SUBJECT: Forwards responses to open items re 820803-06 pump & valve operability review team (PVORT) audit.

Subject: Palo Verde Nuclear Generating Station  
(PVNGS) Units 1, 2 and 3  
Docket Nos. STN-50-528/529/530  
File: 81-056-026, G.1.10

Enclosed are responses to the open items of the Pump and Valve Operability Review Team (PVORT) Audit conducted at the PVNGS site, August 3 through 6, 1982.

CHARGING PUMP  
COVER VENT MOUNTING

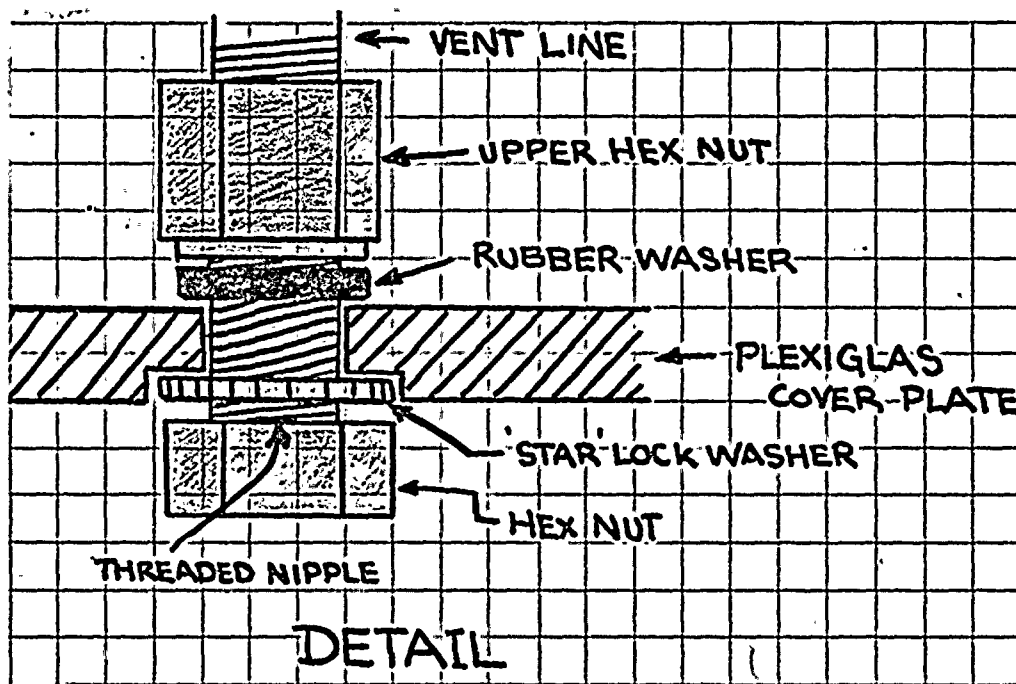
A detailed review of the manufacturer's and vendor's recommended installation configuration for the plexiglas pump cover-plate has revealed the following information:

- 1) As indicated in the PVORT, this cover-plate is to be both sealed (gasketed) and vented to provide an outlet for water or hydrazine vapor which may accumulate in this housing.

- 2) The sealed and vented requirement for the cover, however, is needed to preclude area hydrazine buildup and is essentially at issue only from a room habitability standpoint. It should not effect pump operability, except in its role as a dust cover for the pump pistons. Good industry practice would indicate that the moving parts (i.e. the pistons) should be kept clean and free of abrasive particles which could cause premature wear. An inspection of the pumps of all three units has shown that the pumps in Units 2 & 3 are configured in accordance with the vendors sealing requirements, as in Unit 1 pump 1-P CHA-PO1. Please refer to the attached sketch and pictures. Unit 1 pumps 1-P-CHB-PO1 & 1-P-CHE-PO1 do not conform to this requirement for sealing in that the vent line is smaller than the hole in the cover-plate. Corrective action will be taken to assure that the sealing on these two pumps will be identical or equivalent to the others and provide an equivalent level of personnel safety.

INSTALLATION DETAIL OF THE  
VENTS FOR THE FOLLOWING  
PUMPS:

1-P-CHA-PO1	UNIT 1
2-P-CHA-PO1	} UNIT 2
2-P-CHB-PO1	
2-P-CHE-PO1	
3-P-CHA-PO1	} UNIT 3
3-P-CHB-PO1	
3-P-CHE-PO1
